Application No. 10/797,447  
Response dated April 19, 2005  
Reply to Office Action of January 19, 2005

**AMENDMENTS TO THE DRAWINGS**

# ANNOTATED SHEET SHOWING CHANGES

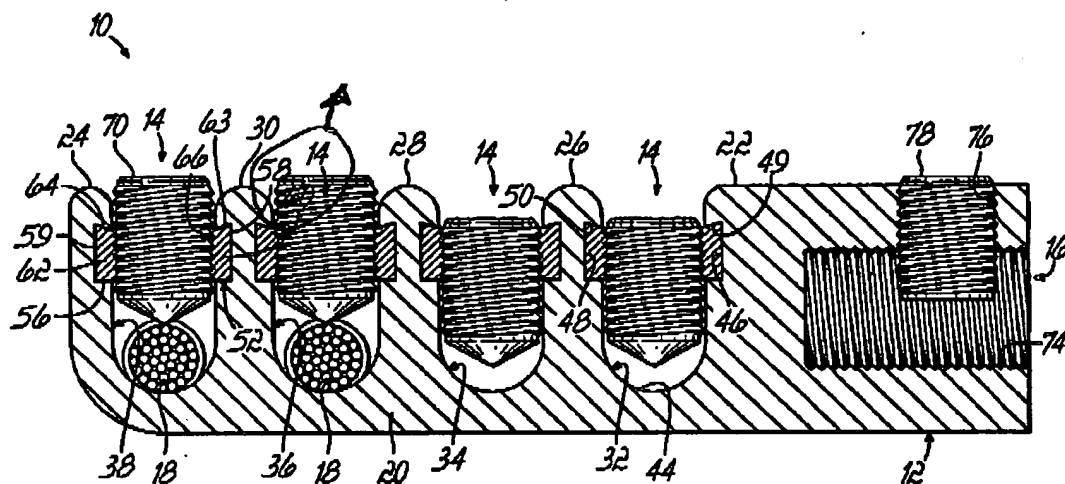
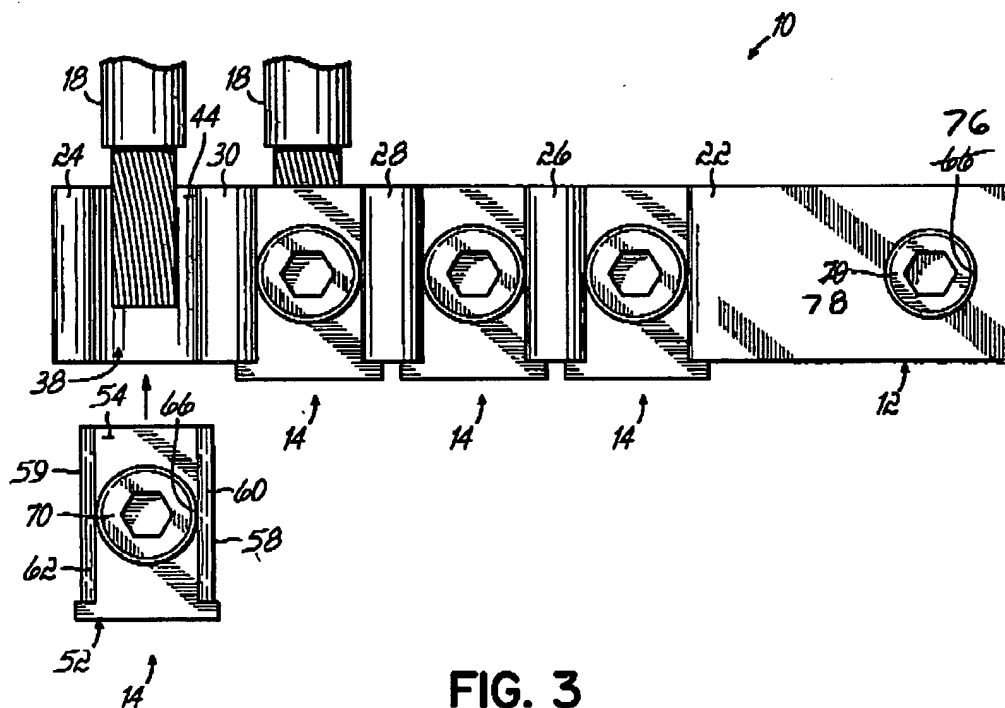
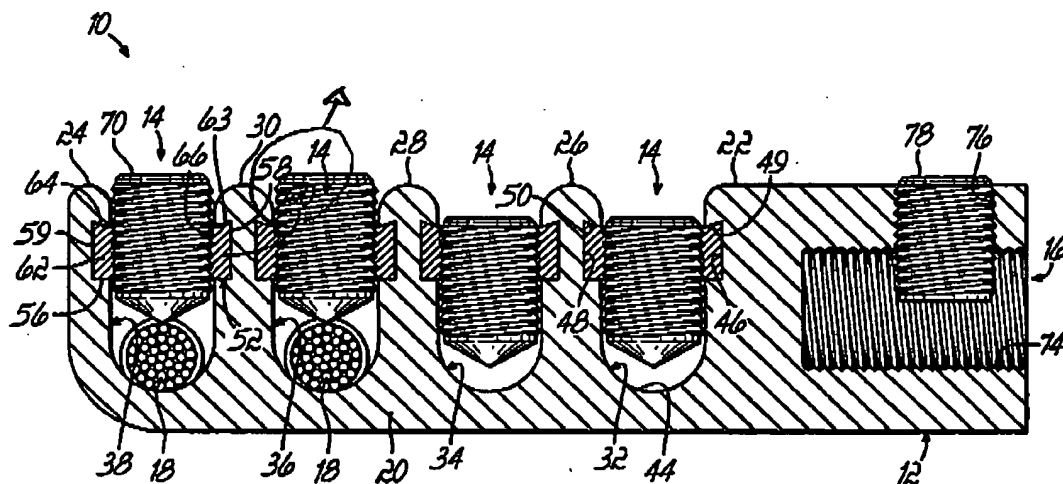
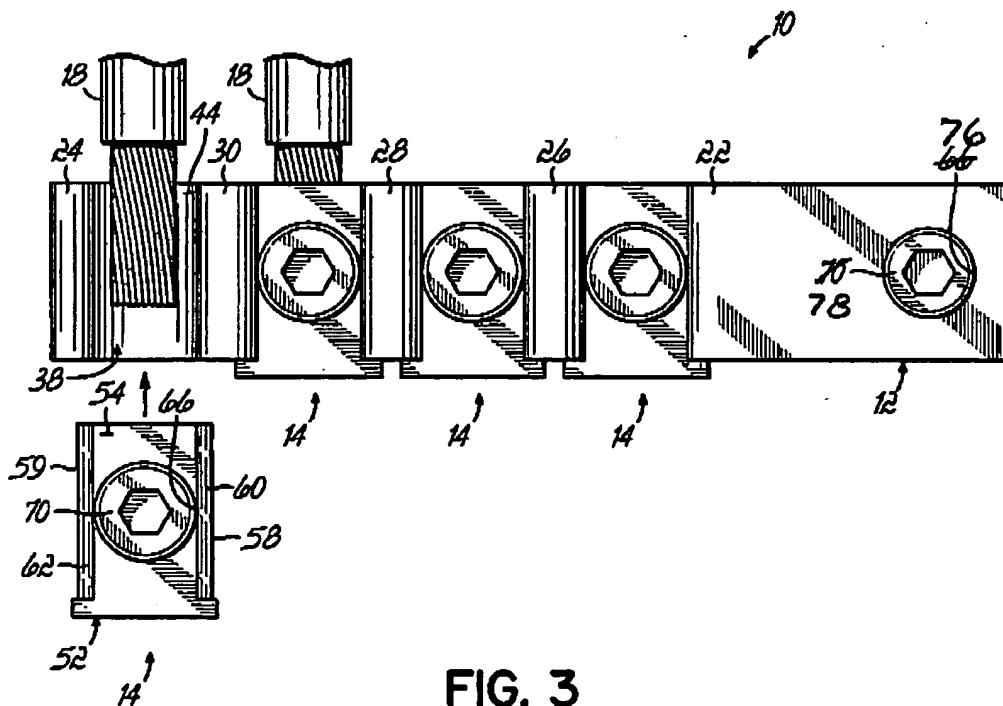
Applicants submit herewith proposed drawing changes to add Figs. 2A-2B and to correct a number of typographical errors in the previous drawings. In particular, the Examiner objected to the drawings for failing to show claimed features recited in claims 6-8 and 19. Figs. 2A-2B show these features more clearly. Moreover, a number of reference numerals (e.g. 14, 60) in Fig. 2 are within the drawing and therefore difficult to see. The reference numerals have been moved outside the drawing. Additionally, the binding screw 78 and threaded opening 76 associated with bore 16 were improperly labeled in Fig. 3. These reference numerals have been changed to correspond to the correct reference numerals used in the specification. The Examiner is respectfully requested to approve these proposed drawing changes. No new matter is being introduced by the revised drawings.

In the Office Action, the drawings were objected to under 37 C.F.R. § 1.83(a) as failing to show every feature of the invention specified in the claims. In particular, the Office Action asserts that the features of claims 6-8 and 19 are unclear as they are not shown in the drawings. Applicants have added new Figs. 2A-2B and amended the description to conform the drawing and specification to the original disclosure in the claims. The drawings have also been amended to correct certain typographical errors. Applicants submit that no new matter is being added by the additional drawings, amendments to the drawings and amendments to the specification. The Examiner is therefore respectfully requested to approve these additional and revised drawings and withdraw the objection.
